ORIGINATION FORM

Proposed Revisions to a Standard Plans Index
(Please provide all information — Incomplete forms will be returned)

Index Number: 630-010
Sheet Number (s): 1 of 4
Index Title: Conduit Details - Embedded

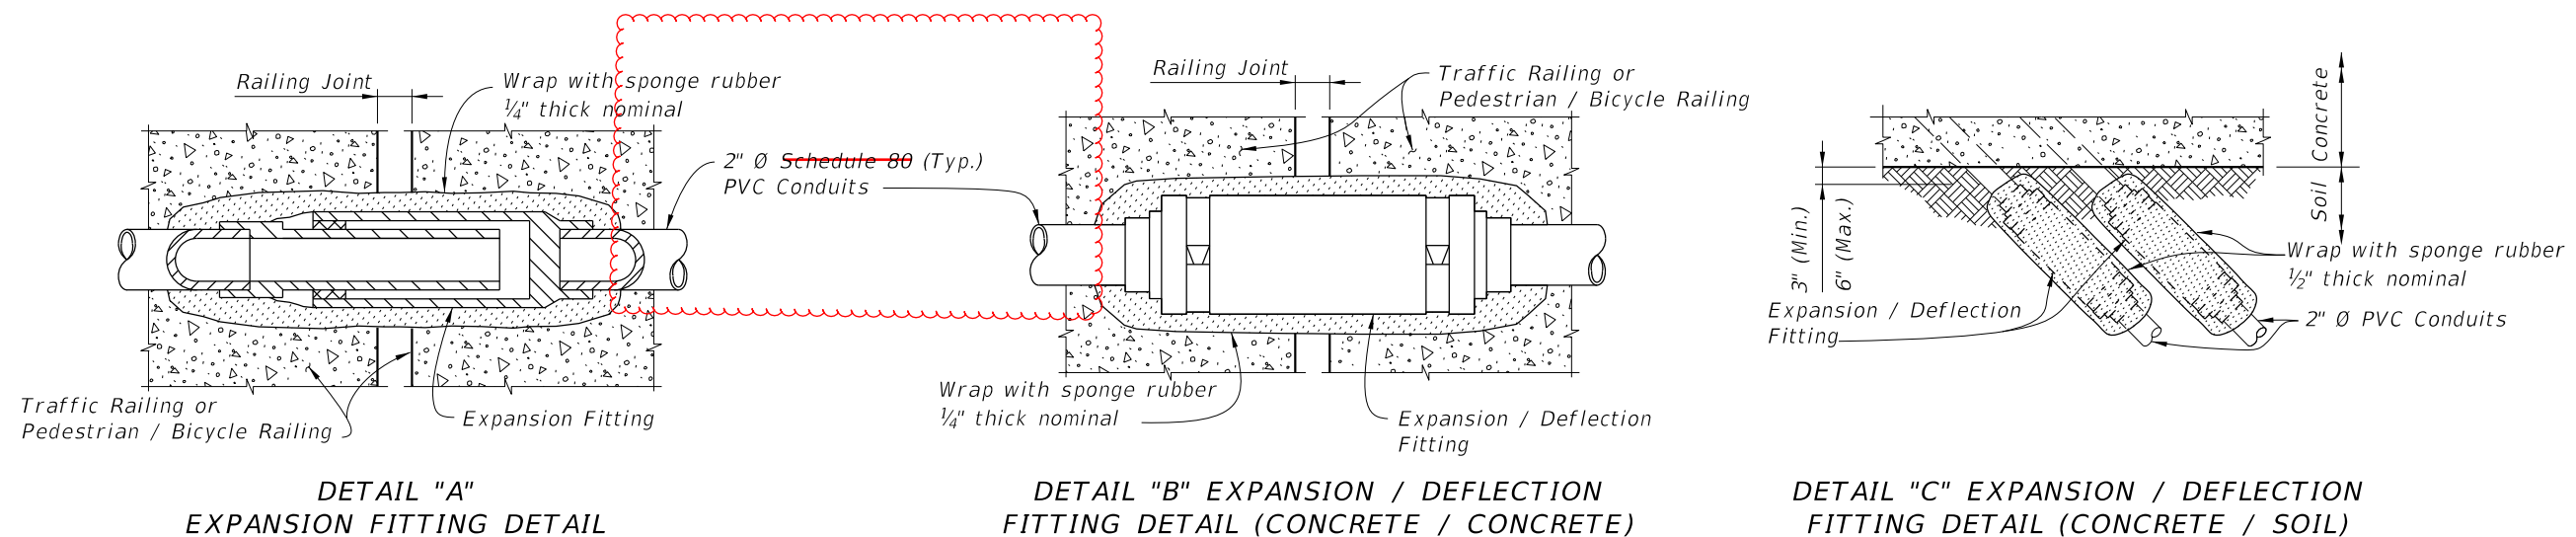
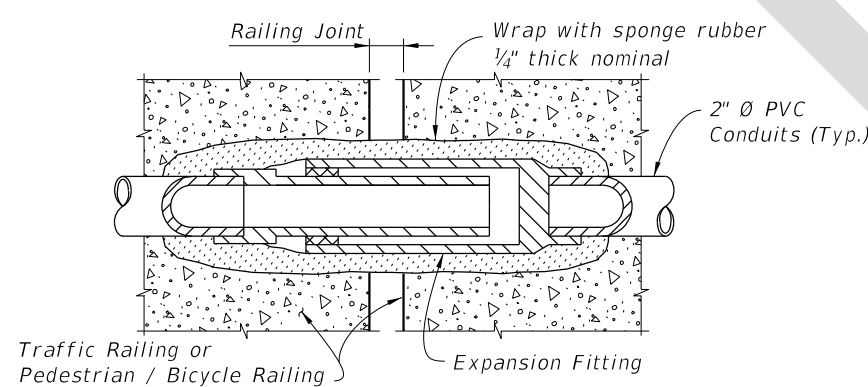
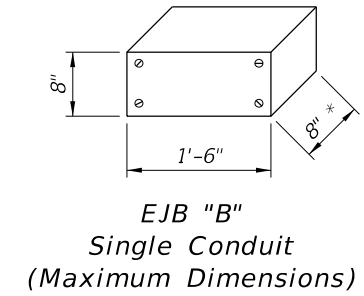
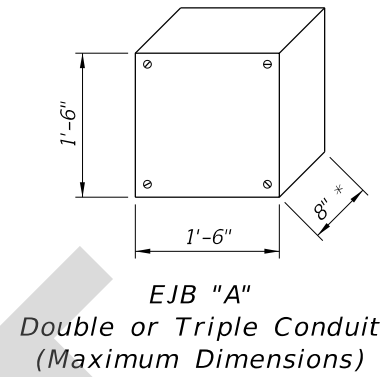
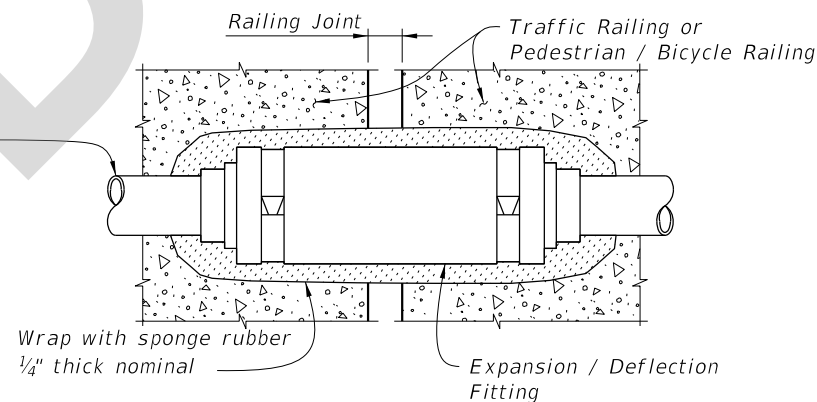
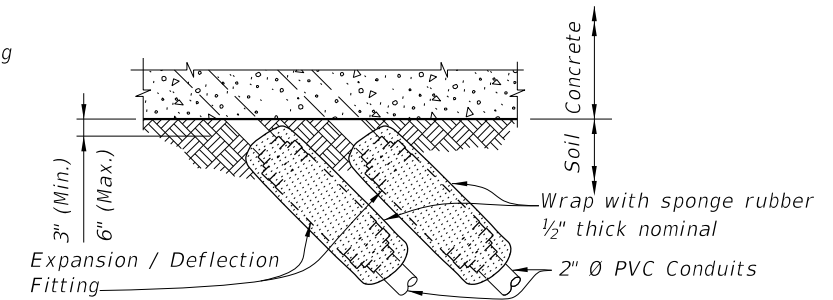
Sheet 1: Revised conduit call out to remove material specification.

Districts agreed with the proposition at the December 2022 TAG meeting to move from Sch 80 to Sch 40. It was decided to remove the material requirements from the Standards as they should be in the Spec.
